County of Fairfax, Virginia

STAFF REPORT

**APPLICATIONS RZ/FDP 2012-MV-008
WAIVER #1183-WPFM-010-1
RESOURCE PROTECTION AREA
ENCROACHMENT EXCEPTION #1183-WRPA-007-1 &
WATER QUALITY IMPACT ASSESSMENT #1183-WQ-010-1**

APPLICANT: The Alexander Company, Inc.

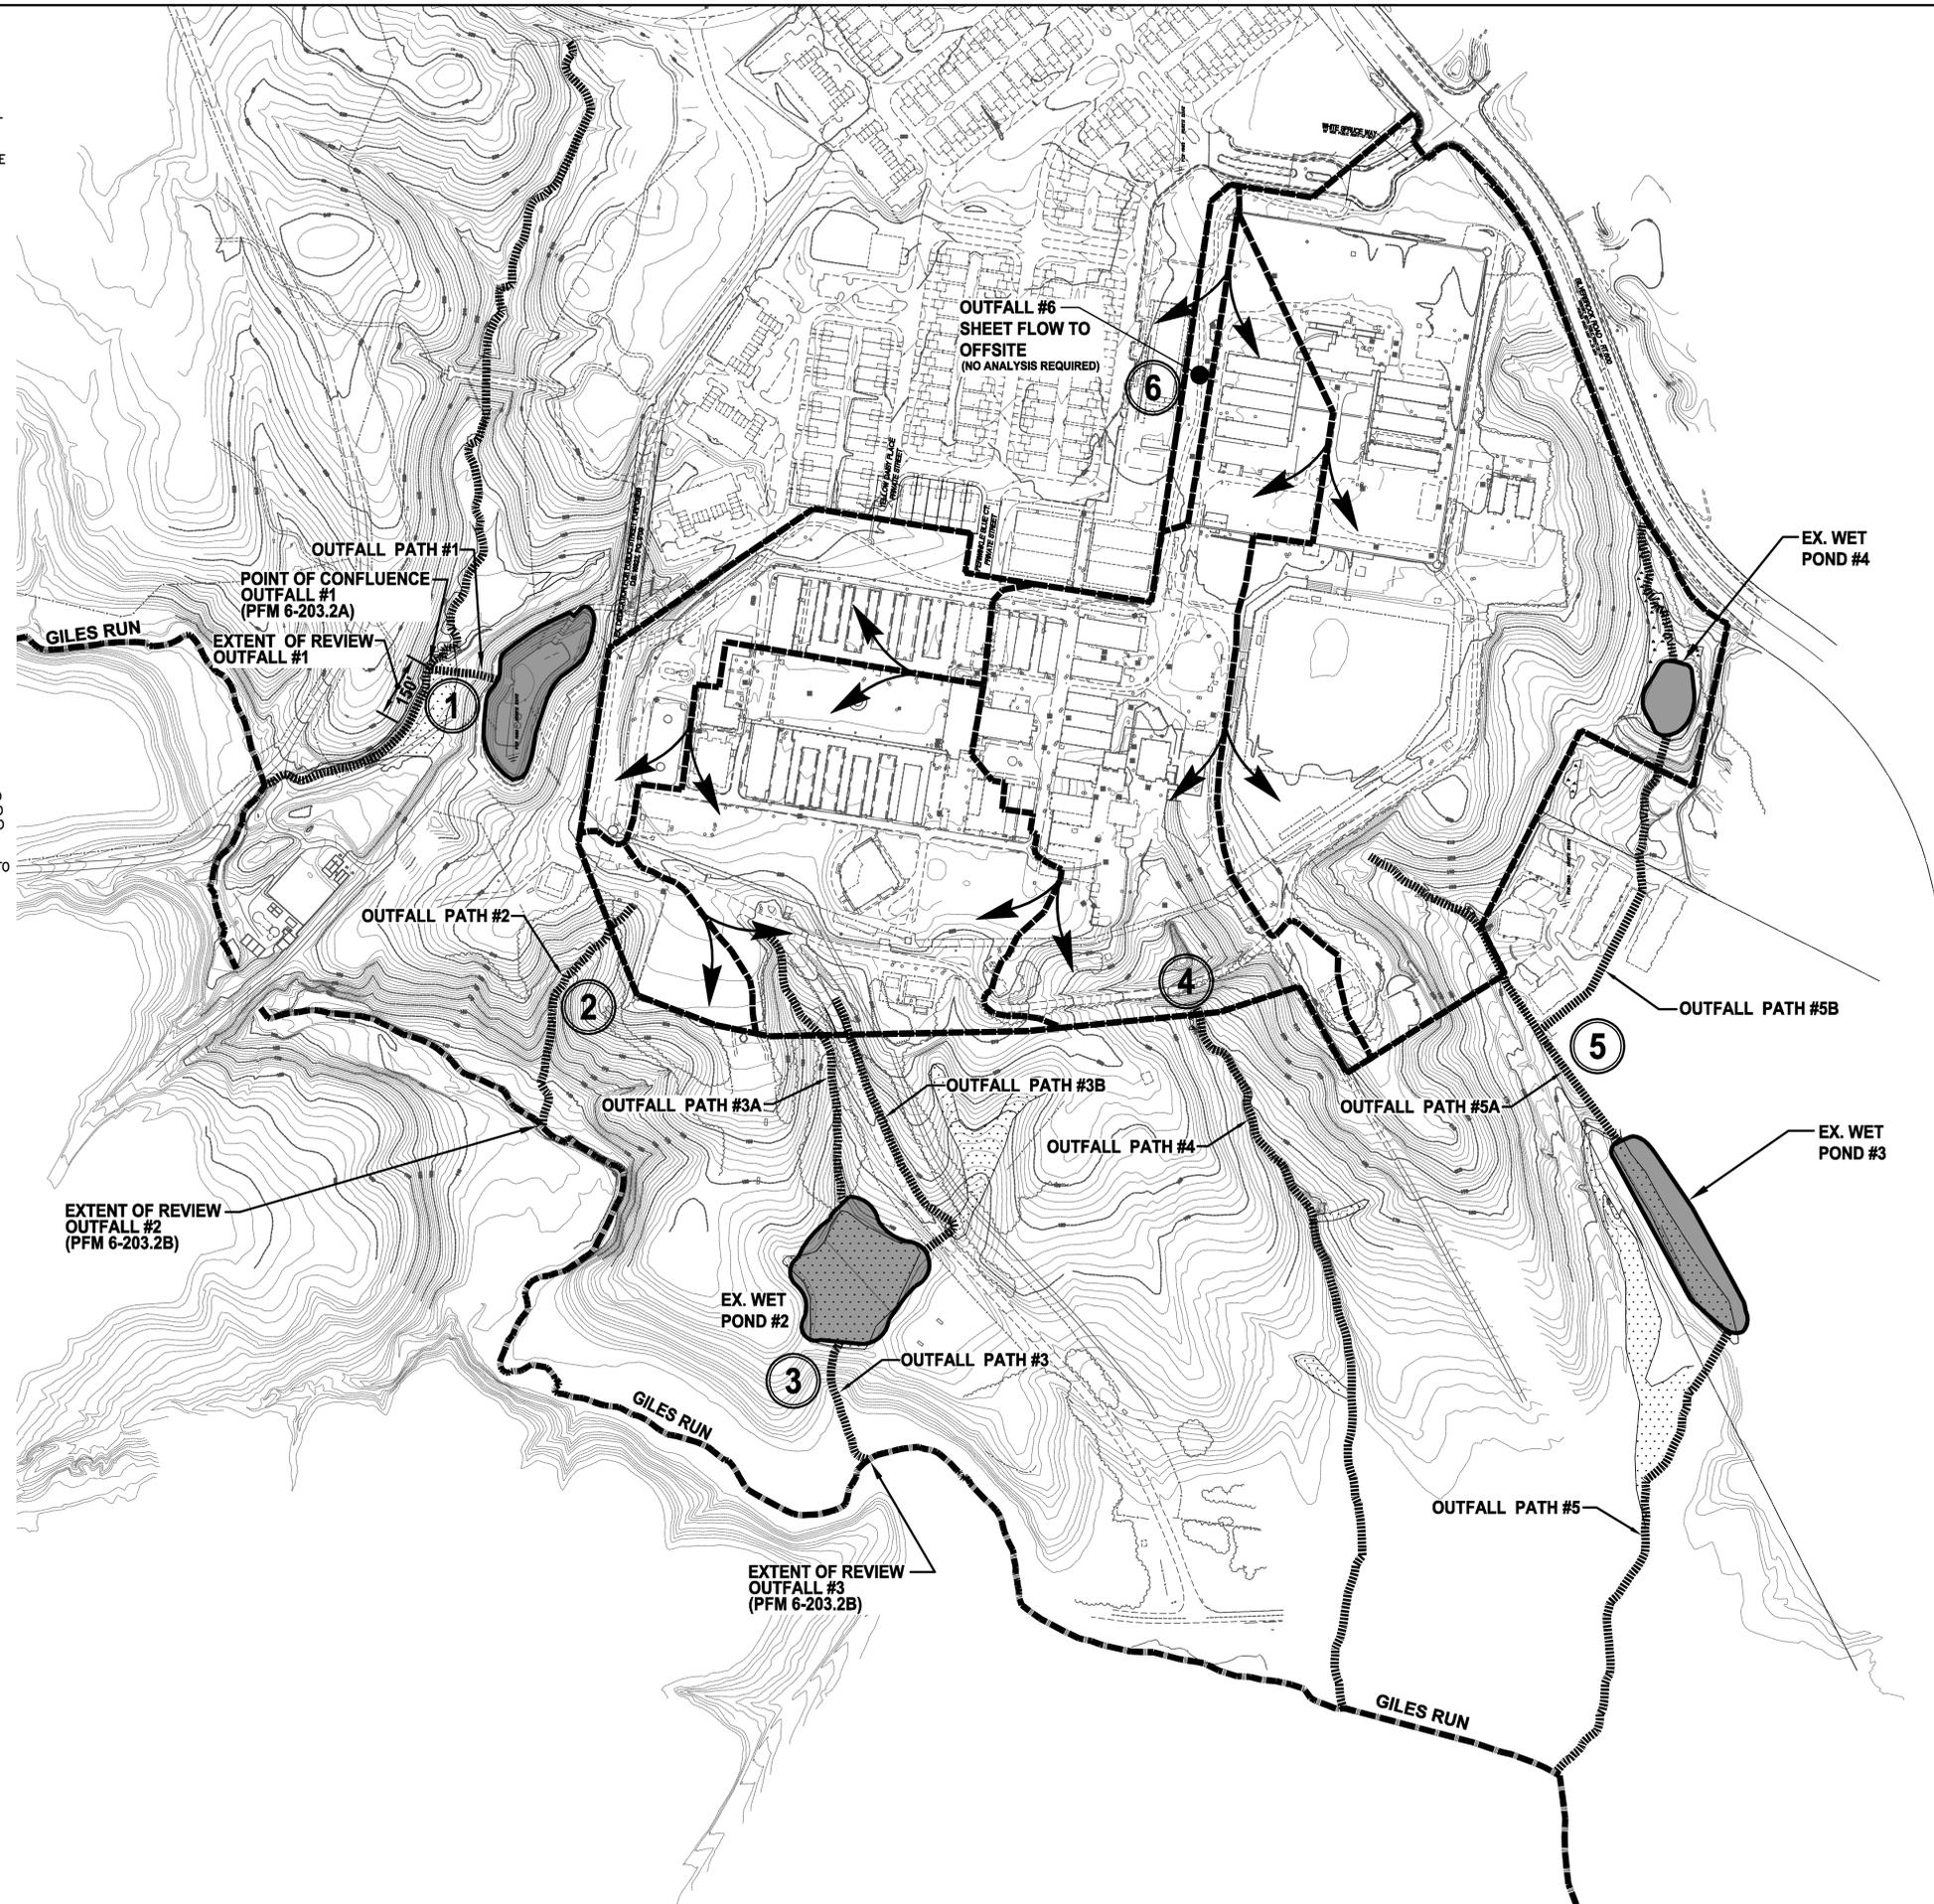
The existing and proposed drainage area tabulation on sheet P-0501 indicates that the natural drainage divide was not honored. It shall be demonstrated that the diversion is necessary to:

Figure 9: PDC Development Option (Source: Walter L. Phillips)

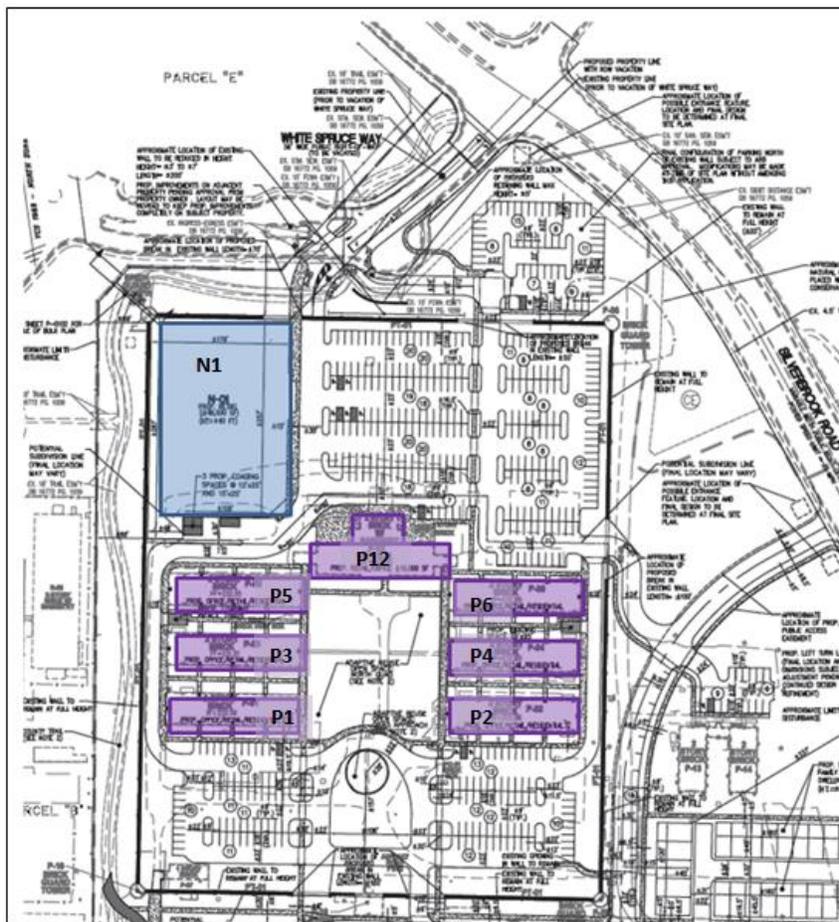
The second option, depicted in Figure 9 (Sheet P-303A) differs only from the first option by providing one new retail building (N1). This building is approximately 49,000 square feet in size and is located to the northwest of the existing buildings instead of three new buildings. Surface parking is proposed where Buildings N1 and N2 would be sited in the previous option. The access into the development and impacts on the penitentiary wall are the same as the previous option. According to the applicant, the second option is proposed in

Figure 10: PDC Development Option (Source: Walter L. Phillips)

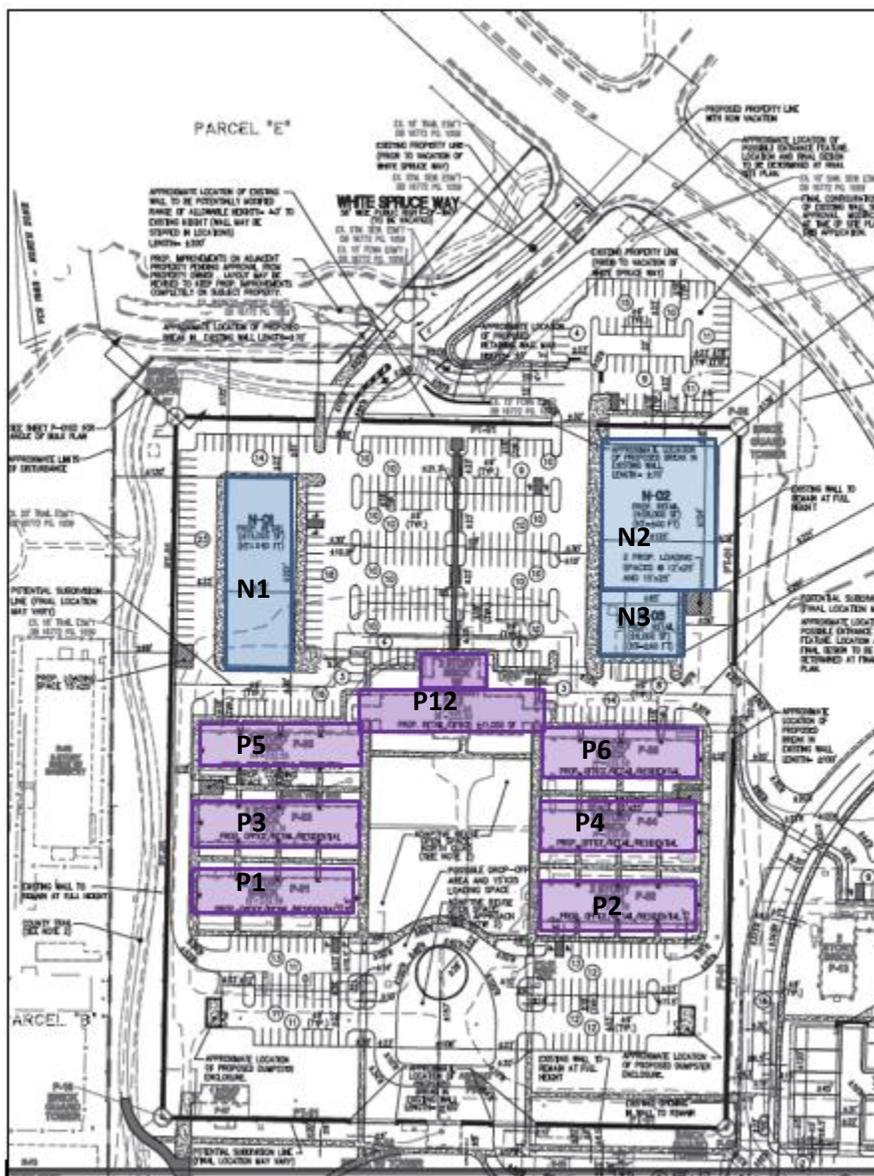
The applicant provided a third option in Figure 10 (Sheet P-303B) that replaces some or all of the office/retail dormitory buildings (P1-P6) with multi-family uses with up to 48 dwelling units (but no more than 50,000 square feet). The residential option requires fewer parking spaces than the all non-residential options provided above. It is also feasible that the applicant could mix and match these three options and provide a single new retail building and multi-family uses or a combination of office, retail and multi-family uses in the six cell blocks. Due to the number of potential options the applicant has depicted three base options and the proffers allow for additional flexibility.

Figure 17: SFD Lot Typical (Source: CDP/FDP)

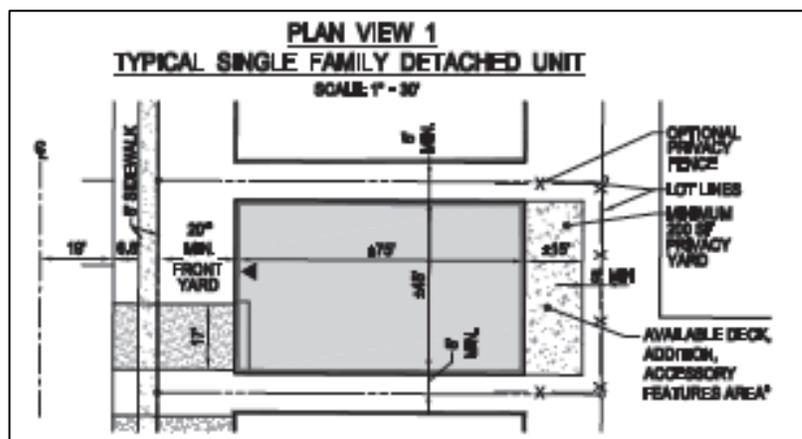
The typical lot layouts shown in Figure 17 have been provided for the single family detached units. There will be a minimum 20-foot front yard, 5-foot side and 20-foot rear yards. The rear yard would be permitted an encroachment of up to 15-feet for a deck, screened porch, sun room or addition.

Figure 18: SFA Lot Typical (Source: CDP/FDP)

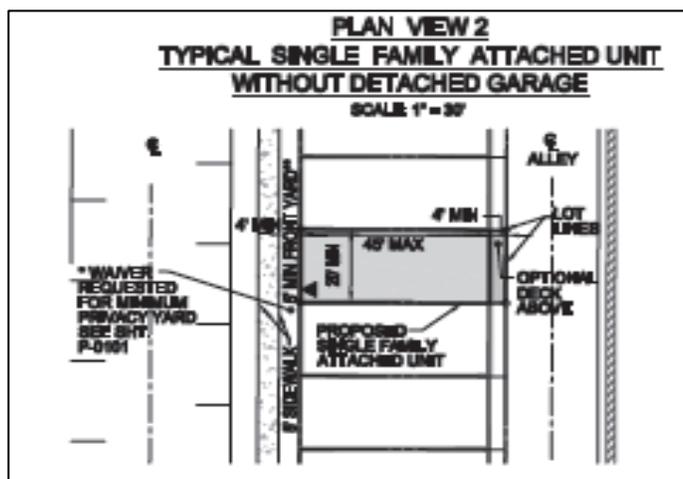
The typical lot layout for the single family attached units are in Figure 18. Single family attached units will have access to the garage from an alley and the units will front onto a private street or open space. The lots will be a minimum of 16 feet wide and maximum of 45 feet long. The lots will have a five foot front yard that may contain stoops. A waiver of the 200 foot privacy yard is requested. As noted the rear of the unit will front onto an alley with a minimum four foot garage apron and optional deck above the garage apron.
